DETAILED ACTION

Art Unit: 3775

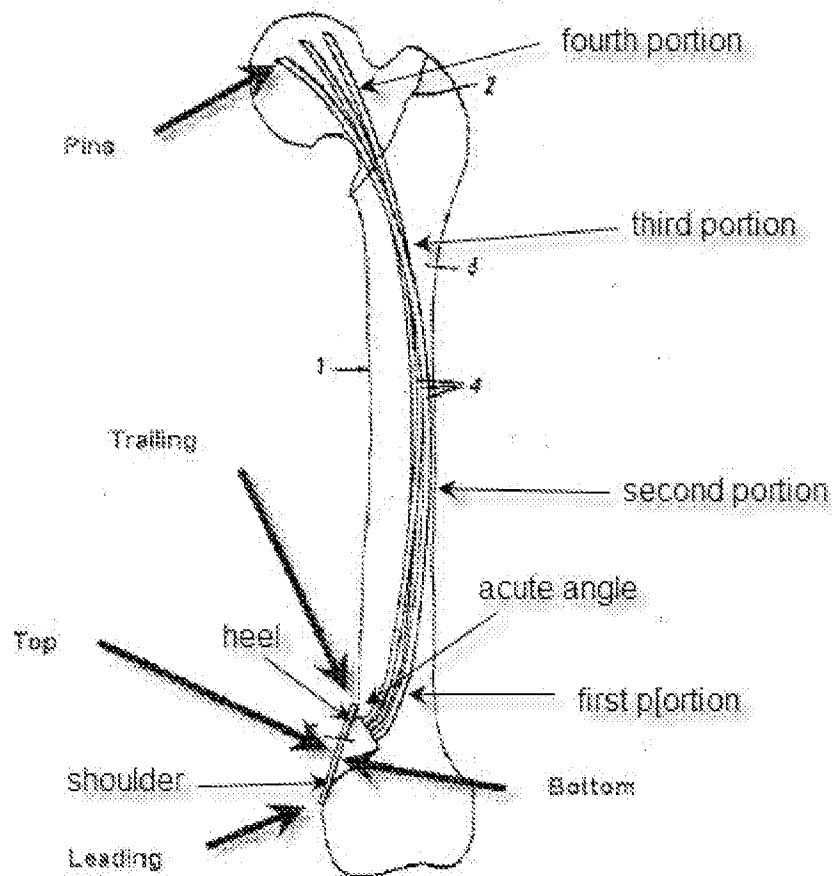
Ender discloses a longitudinally extending intrafocal plate (7, Fig. 7) capable of securing bone fractures, said intrafocal plate (7) comprising a flat, elongated intrafocal plate element (Fig., 2) having a surface at one end thereof defining a top and a bottom and a leading end (first end as for claim 21) and a trailing end (second end) (see modified Fig. 1 below); an intermediate location between the leading and trailing ends

(Fig. 1), wherein the second end is capable to overlay a fracture site and capable to prevent over reduction of the fracture site. After inserting the device of Ender into the bone, a longitudinally extending intrafocal resilient body element (4, Fig. 1) (col. 4, line 48) is connected to a tubular piece (8, Fig. 3) which is integral to the intrafocal plate element (7, Fig. 3), and wherein the tubular piece (8) can be considered as a part of the resilient body element (4), therefore the resilient body element (4) can be considered integral to or a single piece with the intrafocal plate element (7) adjacent to but spaced apart from the trailing end (second end) of the surface of the plate element (Fig. 1) so that the leading end of the surface of the plate element extends above the location at which the resilient body element is affixed to the surface of the plate element (Fig. 1) so that the body element forms an acute angle with the surface and extends generally in the lengthwise direction of the surface (Fig. 1). The resilient body element is orthogonal to the surface of the plate element according to a side elevation view (First plane) of the resilient body element (Fig. 1) and a substantially straight shape according to a top elevation view (second plane) of the resilient body element parallel to the bottom surface of the elongate plate element, wherein the body element has a first portion, a second portion, a third portion and a fourth portion (see modified Fig. 1 below). The second end of the plate element extends adjacent to a portion of the body element (4) and maintains the plate element proximate the fracture site; and so as to define an overhanging heel (see

modified Fig.1 below) between the location at which the resilient body element is affixed to the surface of the plate element and the trailing end of the surface, the overhanging heel extending downwardly (Fig. 7) below the location at which the resilient body element is secured to the surface of the plate element, wherein the heel serves to help stabilize the fracture site, the resilient body element (4) being formed so as to extend generally in a lengthwise direction of the surface depending downwardly and outwardly from the bottom of the surface (Fig. 1) and wherein the other end of the resilient body element defines a pin element (see modified Fig. 1 below). A shoulder (see modified fig. 1 below) at one end at the juncture of the resilient body element and the surface and is defined between the surface and the one end of the body element connected thereto. The surface defines one or more apertures (9, Fig. 2) therein. The intrafocal plate including one or more screws (col. 5, lines 25-29) for insertion through one or more apertures (9) defined in the surface of the plate element to secure the plate element to the fracture site.

Ender discloses an intrafocal plate (7, Fig. 7) capable of securing bone fractures comprising: an elongate plate element defining a leading ending, a trailing end, an intermediate location between the leading and trailing ends, an overhanging heel toward the trailing end (see modified Fig. 1 above) capable to prevent reduction of a fracture and to stabilize the intrafocal plate when inserted

into a fracture site of a bone, a top surface, and a bottom surface (see modified Fig. 1 above) that is configured to engage an outer surface of a bone; and After inserting the device of Ender into the bone, a longitudinally extending intrafocal resilient body element (4, Fig. 1) (col. 4, line 48) is connected to a tubular piece (8, Fig. 3) which is integral to the intrafocal plate element (7, Fig. 3), and wherein the tubular piece (8) can be considered as a part of the resilient body element (4), therefore the resilient body element (4) can be considered integral to or a single piece with the intrafocal plate element (7) and extending downwardly from the bottom surface of the elongate plate element and in a lengthwise direction relative to the elongate plate element beyond a terminal end of the elongate plate element (Fig. 1), the resilient body extending from the intermediate location of the elongate plate element such that the overhanging heel of the elongate plate element is located between the resilient body element and the trailing end of the elongate plate element (see modified Fig. 1 above).
